APPLICATION NO.	FILING DATE	FIRST NAMED INVENTOR	ATTORNEY DOCKET NO.	CONFIRMATION NO.
10/808,625	03/24/2004	Yuji Tanaka	16869S-112300US	6080
20350	7590	08/18/2006	EXAMINER	
TOWNSEND AND TOWNSEND AND CREW, LLP TWO EMBARCADERO CENTER EIGHTH FLOOR SAN FRANCISCO, CA 94111-3834			BANKHEAD, GENE LOUIS	
			ART UNIT	PAPER NUMBER
			3744

Office Action Summary

DETAILED ACTION

Figure 9 Satoh et al. (US 2003/0131621 A1)

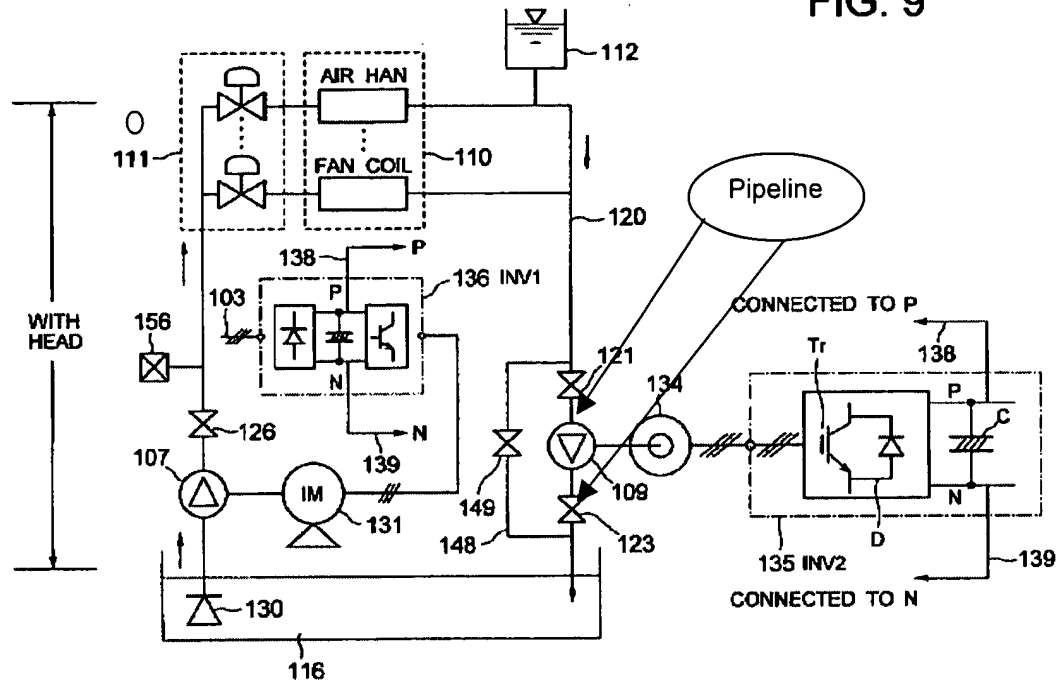
Satoh et al. teach an air conditioning system with a tank 116, a feed pipe line 130 (generally as indicated as 130) that is capable of feeding a fluid from the tank to an air conditioning load 110 via a water pump 107. They further teach a return pipe line 120 for leading a fluid, after it has left the air conditioning load, back into the tank. Satoh et al. further teach a valve 149, capable of maintaining an upstream pressure (column 8 lines 64-65 and column 9 lines 1-5), in the return pipe line; and a branch pipe line, (generally indicated as the line including elements 121, 109 and 123), connected to the return pipe line upstream of valve 149. They further teach an energy recovery apparatus (elements 134 and 109) connected in the branch pipe line, (see Figure 9).

Though Satoh et al. does not teach a bore diameter of the pipe line downstream of the energy apparatus as being smaller than the diameter of the upstream pipeline, see Figure 9, it would have been obvious to one of ordinary skill at the time of the invention because simple fluid mechanics teaches the greater the amount of fluid, the greater the amount of energy that is able to be recovered. Thus, in order to recover as much energy as possible, it would be obvious to use a larger diameter pipe to recover more fluid, and then to reduce the diameter of the pipe after the energy from the fluid has been recovered. In addition conservation of mass teaches that as the fluid leaves the upstream pipeline and flows into the downstream pipeline the velocity of the fluid increases, advantageously reducing the likeliness of an excessive pressure drop.

Figure 11 Satoh et al. (US 2003/0131621 A1)

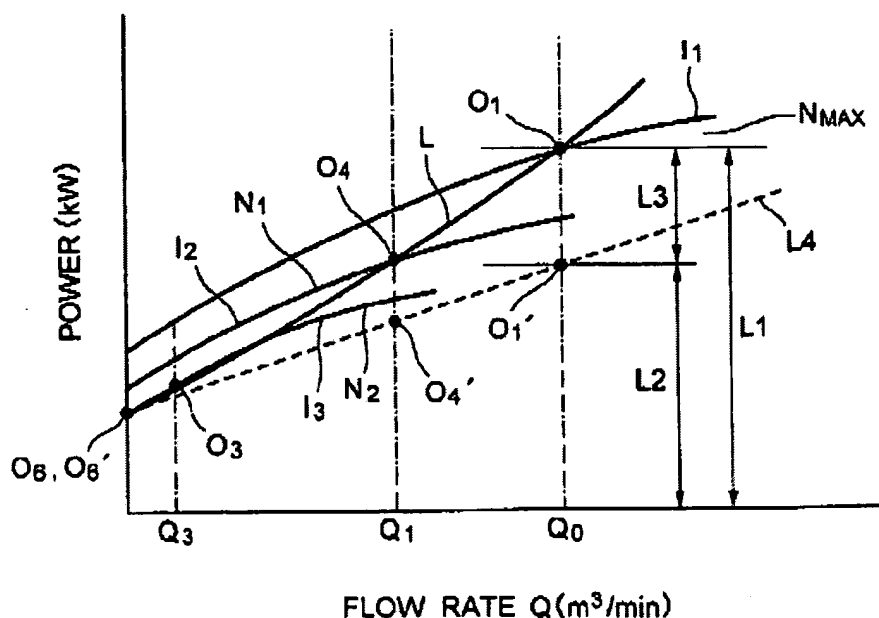
In regard to claim 3, Satoh et al. teach an energy recovery apparatus with an operation control device 135 capable of controlling the operation of the energy recovery apparatus such that an inlet pressure falls within a predetermined water flow rate range of Q3 to Q0 with respect to an inlet pressure during its operation (column 2 lines 1-5, column 9 lines 10-20, column 10 lines 40-60). Note, Satoh teaches, in Figure 11, the flow rate onto the waterwheel of the energy recovery apparatus varies with the power generated by the electric generator 134. One of ordinary skill in the art would have known that an inlet pressure into the energy recovery apparatus varies with the water flow rate entering the waterwheel.
